Huntsville, Alabama

Cover Memo

Resolution authorizing the Mayor to execute Change Order No. 1 and Change Order No. 2 to the Agreement between the City of Huntsville, Alabama and Redmond Construction for the Von Braun Center Existing Kitchen Modernization project awarded pursuant to Resolution No. 25-129.

Resolution includes two change orders. Change Order No. 1 in the amount of \$30,870.02 and Change Order No. 2 in the amount of \$223,222.53. The changes orders increase the total contract amount from \$4,833,222.00 to \$5,087,314.55.

RFI #	3
		Date	5/1/2025
		Date Needed	5/8/2025
TO:	Kevin Overton / Russell	Project Name	VBC - Existing Kitchen Modernization
	Matheny Goldmon Architecture + Interiors	Project #	23-012 - MG, 2505 - Redmond

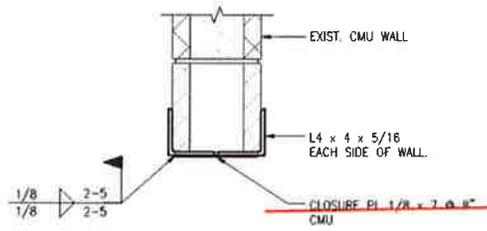
Our proposed solution is to install 4X4X5/16" angle iron per the structural drawing (Double Angle Lintel on S1.0) without the closure plate for temporary support and infill the block above to create a load path for the floating block.

This detail for temporary shoring and infilling the CMU wall is acceptable. John Powell with PEC confirmed on site that the lintel is a stable fix until the door opening can be filled in with CMU.

Item 1

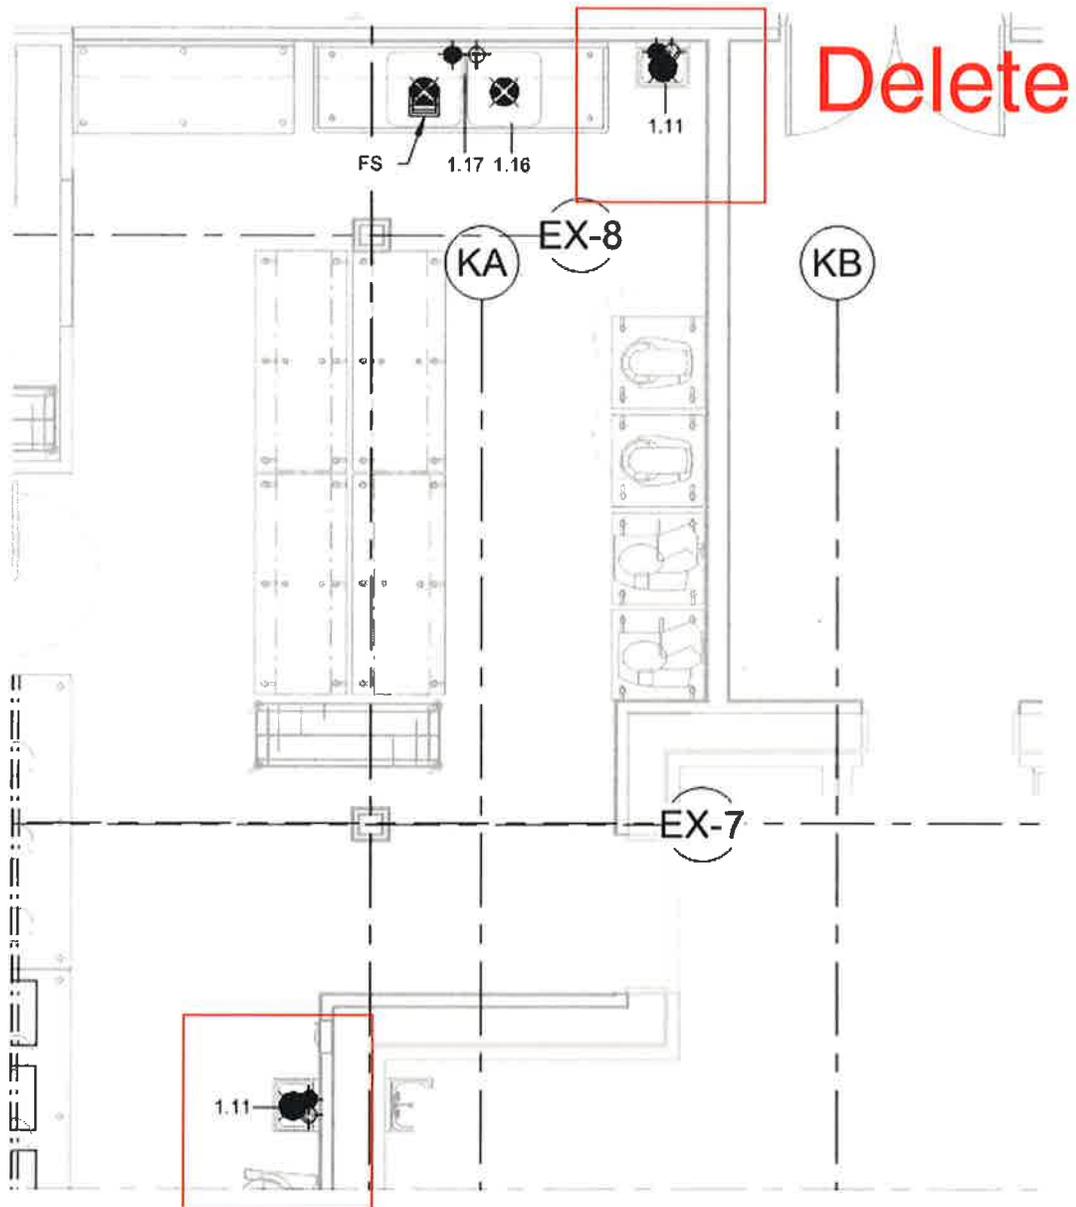
1. Remove hand sink in the southeast corner of the kitchen due to another hand wash sink in the vicinity. Kevin was going to review with the Health Department. Tom said that the hand sink must be within 25' of the double sink in the SE corner. We did a field laser shot and it was 28' in distance.
2. Swap the equipment pieces 1.60 and 1.59.
3. Upgrade the floor troughs for the tilt skillets from the 1.67 (1' X 2') floor trough to the 1.65 (2' X 3') floor trough. There are 3 floor troughs at the tilt skillets. Approximate cost for the upgraded floor troughs is \$2,100 for three new floor troughs. A separate concrete pour may be required due to lead time.
4. Additional Pot Filler - Not listed on the email is an additional pot filler at the tilt skillet location. Kevin had a specific pot filler with a SS braided hose that he could leave in the pot filler for filling the 40 gallons.

Kevin thinks that this sink will cover the health department rule. Approximately 28' away.

Cooler 103 Sketches

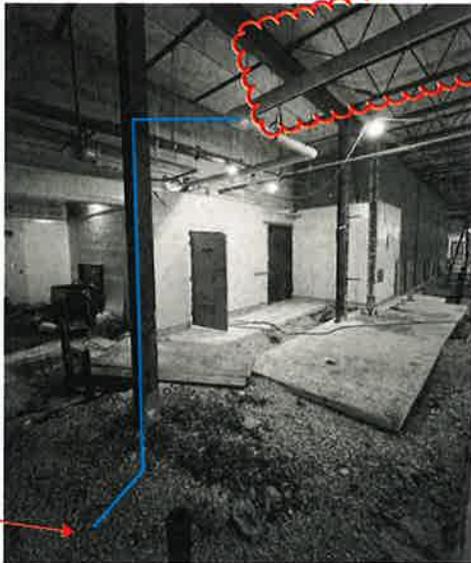
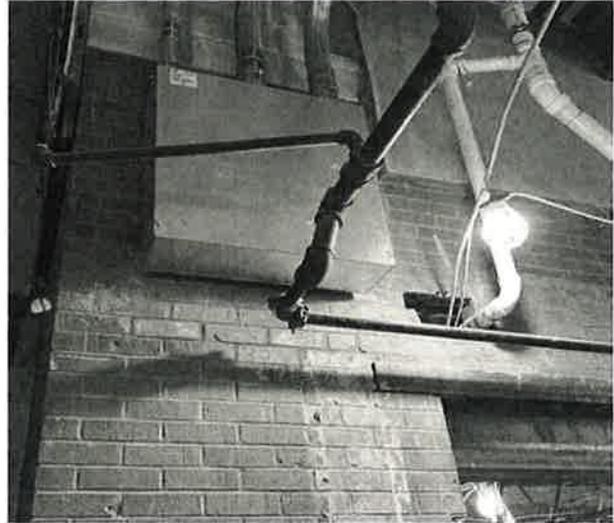
Delete this run. Tie into South Side Column

Delete this run. Tie into South Side Column

Terminate to existing storm sewer

Run down column and tie into the existing storm sewer run.

APPROVED TO TIE TO SOUTH SIDE COLUMN AND TERMINATE TO EXISTING STORM SEWER

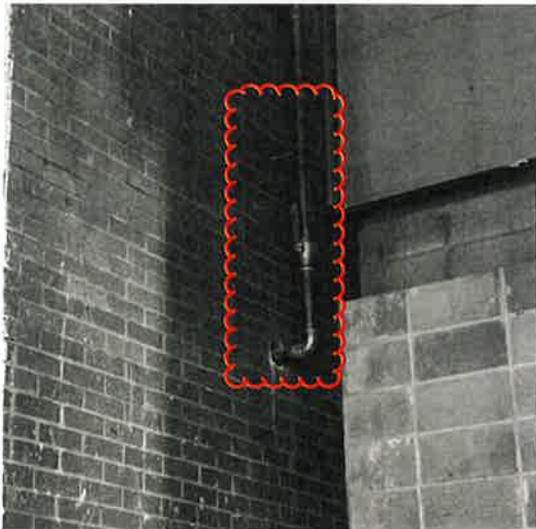
Raise these conduits approximately 1" for clearance for the freezer panel installation.

Relocate the sprinkler pipe away from access panel and keep above 10'8" for freezer clearance.

Recess this run into the brick. Bust out brick and move pipe to inside void. Relocate valve to above freezer panel.

APPROVED TO RELOCATE
SPRINKLER PIPE

Sprinkler Drain Pipe in Kitchen

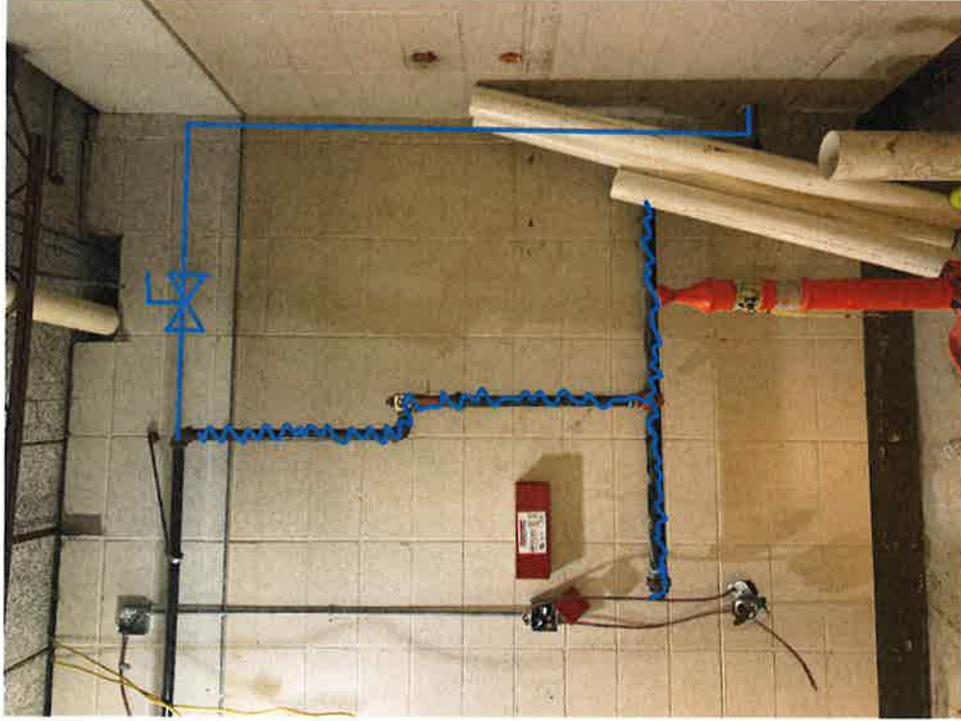
Can you give us a price to demo the standpipe down and fill with concrete as well as reroute the test drainpipe to above ceiling all the way to the existing CMU wall and then turn down and out through the current hole in the wall? Call me if you have any questions.

Duct Penetration #s

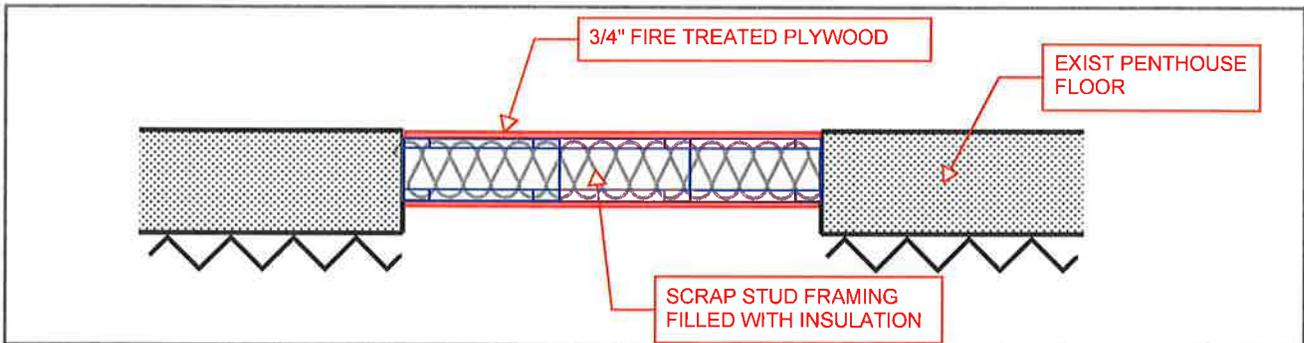
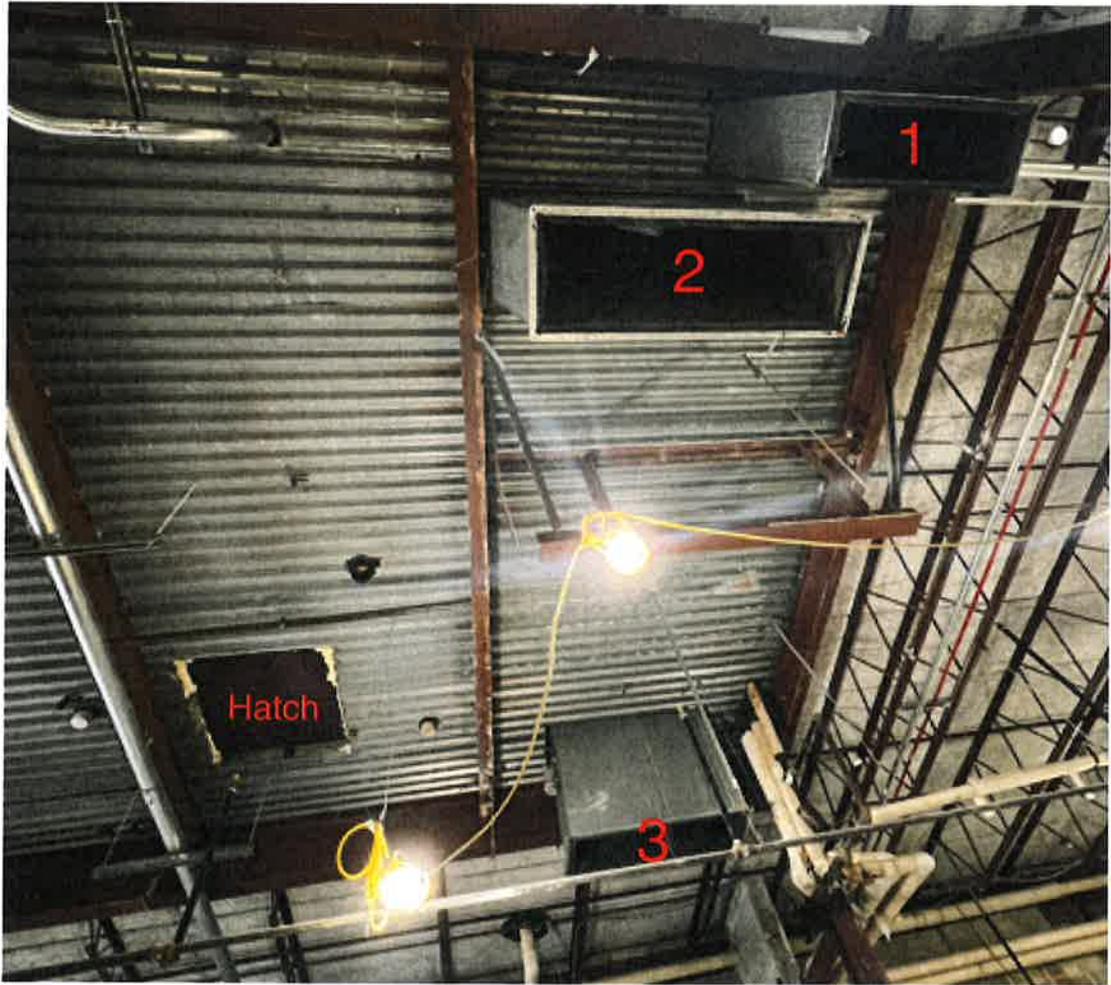
Duct Penetration 1 - SE Corner - JSI would like to use for electrical feeds into the penthouse. Complete Coverup with drilled holes. - 15" X 35"
Duct Penetration 2 - SE Corner - Complete Coverup. - 18" X 54"
Duct Penetration 3 - NE Corner - Complete Coverup. - 18" X 50"
Duct Penetration 4 - Already Capped Off.

Also, there is a 6" Gap along the entire east side of the

Per our discussion on site with PEC and Redmond, proceed with infilling the duct penetrations with scrap pieces of metal studs for framing. Sheath the top and bottom with fire treated plywood. Infill studs with insulation per owner's request. Architect's recommendation - R-19 batts. Seal around perimeter of opening.

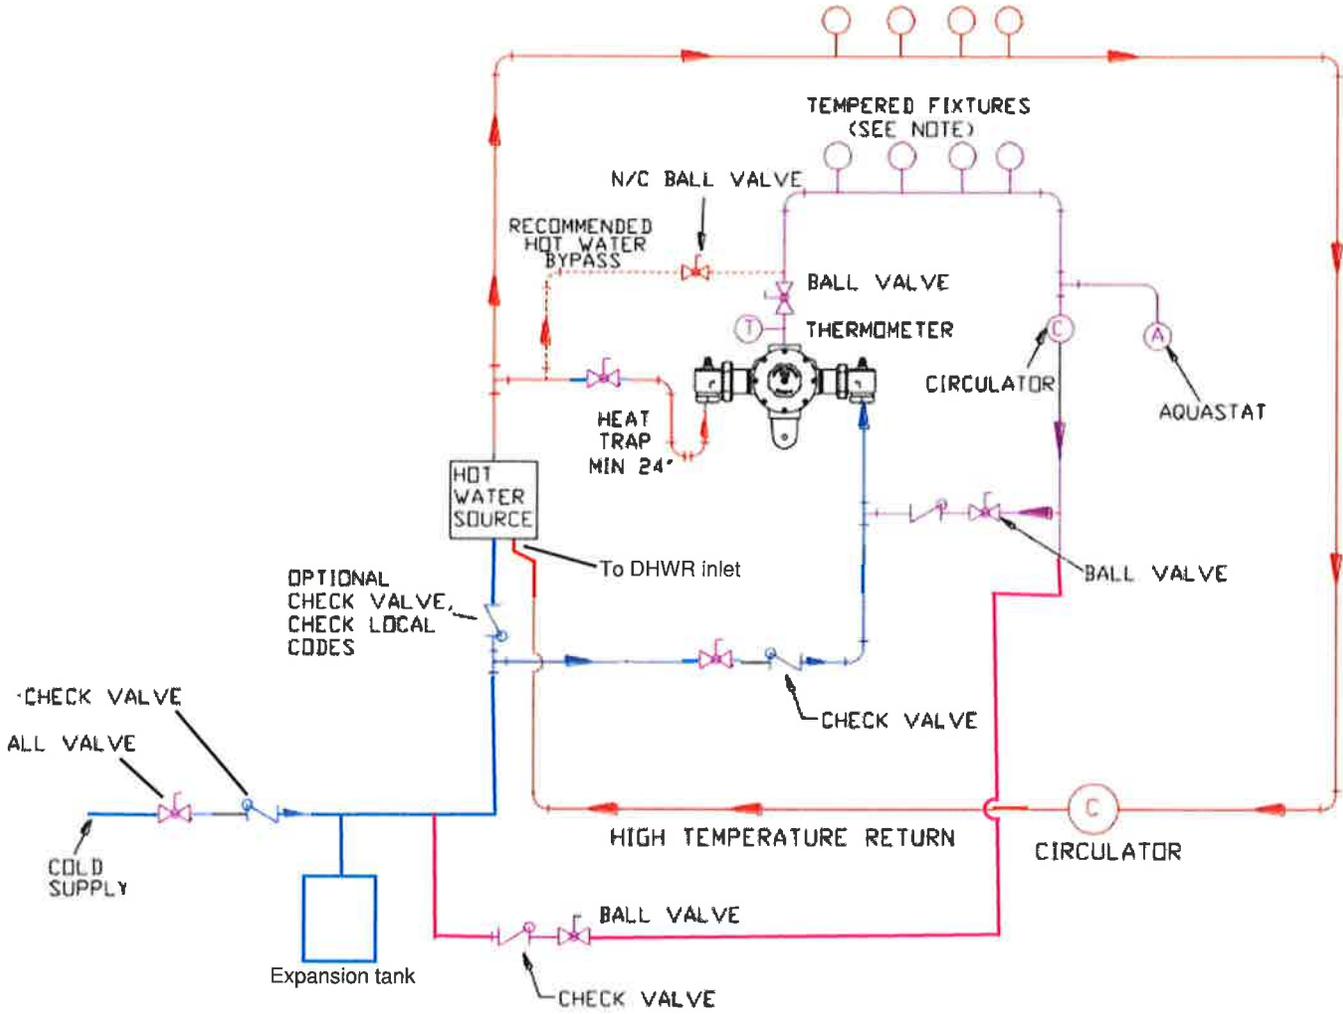
See sheet 3 for comments

See revised piping schematic, page 2. Configuring the returns in this manner will allow each loop to maintain its required temperature without influencing the other. The only modification needed is to reroute the lower temperature HWR return so that it ties back into the DCW supply after the expansion tank rather than connecting into the high temperature HWR.
